Access Compliance Report Public Rights-of-Way (Curb Ramps)

Main Street: CORAZON_ST		Cross Street: DANZA_ST		Location:	S
ADA ID: RPRK211116135208	Ramp Type: Type 4 - Parallel	Initial Pass/Fail: Pass	Overall Compliance: No	Severity Score:	5
Codes/Mitigation Info/Possible Solution			Field Measurements/Component Compliance

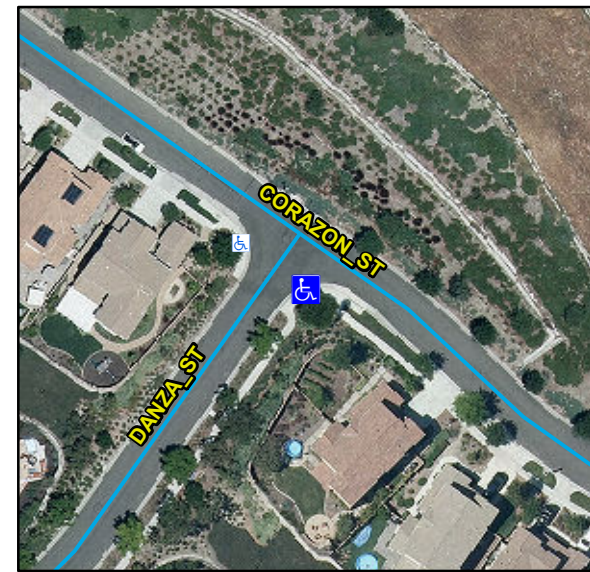
Remove & Replace Landing. Remove & Replace Gutter.

R304.5.3, STD 1115
